H1
MountingHole
H2
MountingHole
H3
MountingHole
H4
MountingHole
Power
File: Power.kicad_sch
Connectors
CLK
MOSI
MISO
CS0
CS1
DIAG
VIR-RTN
File: Connectors.kicad_sch
DAC
CLK
MOSI
CS0
CURRENT-ADJUST
File: DAC.kicad_sch
ADC
CLK
MOSI
MISO
CS1
LDO-SENSE
CUR-SENSE
File: ADC.kicad_sch
LED
File: IRLED.kicad_sch
CC Sink
MOSI
DIAG
CURRENT-ADJUST
CUR-SENSE
LDO-SENSE
VIR-RTN
File: Strobe Generation.kicad_sch
PiTrac
Sheet: /
File: V3 Connector + IRLED.kicad_sch
Title: V3 Connector + IRLED
Size: A4
Date: 2026-02-12
Rev: V1
KiCad E.D.A. 9.0.8
Id: 1/7

PiTrac		
Sheet: /Connectors/		
File: Connectors.kicad_sch		
Title: V3 Connector + IRLED		
Size: A	Date: 2026-02-12	**Rev: V1**
KiCad E.D.A. 9.0.8		Id: 2/7

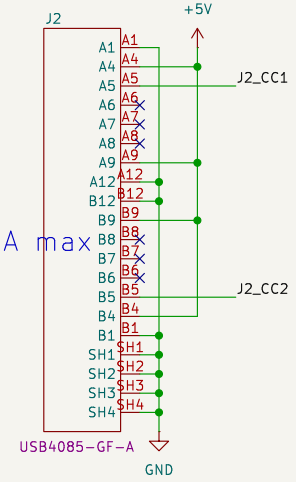
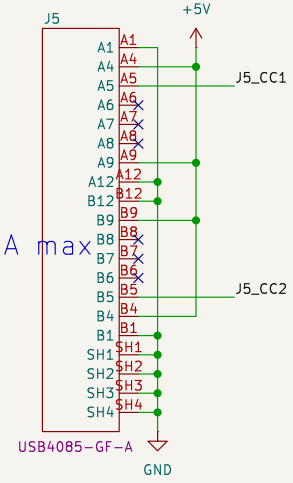
USB-C source advertisement (added).
J2/J5 supply 5 V to the Pis, so each CC pin gets a 10K pull-up to +5V (Rp, "3.0 A" per USB Type-C).
Without Rp a compliant sink may treat the port as unpowered/default-current.
A Pi 5 still limits USB peripherals to 600 mA unless usb_max_current_enable=1 (no BSB-PDM-01 this board).

USB-C 5V: 3A advertised (CC), 5A max

USB-C 5V: 3A advertised (CC), 5A max

PiTrac		
Sheet: /Power/		
File: Power.kicad_sch		
Title: V3 Connector + IRLED		
Size: A4	Date: 2026-02-12	**Rev: V1**
KiCad E.D.A. 9.0.8		Id: 3/7

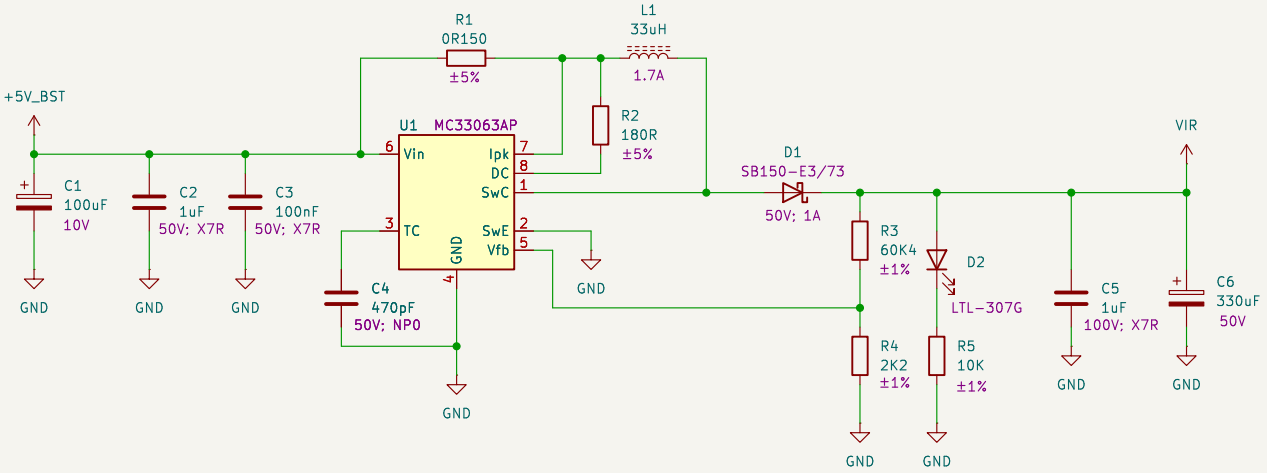
Protection (added).
F1: resettable fuse in the boost input only (not in the +5V path to the Pis). It limits a VIR short (e.g. C6, D16 or an LED/MOSFET failing short), which the MC33063 current limit cannot stop because current flows 5V > R1 > L1 > D1 directly.
D16: clamps VIR if the feedback divider (R3/R4) opens. VBR(min) 37.1 V is above worst-case normal VIR (~36.8 V). It is a clamp-then-fail-short scheme that relies on F1; the MC33063 (40 V) may not survive that fault, but the capacitors, LM317L, MOSFETs and LEDs are protected.
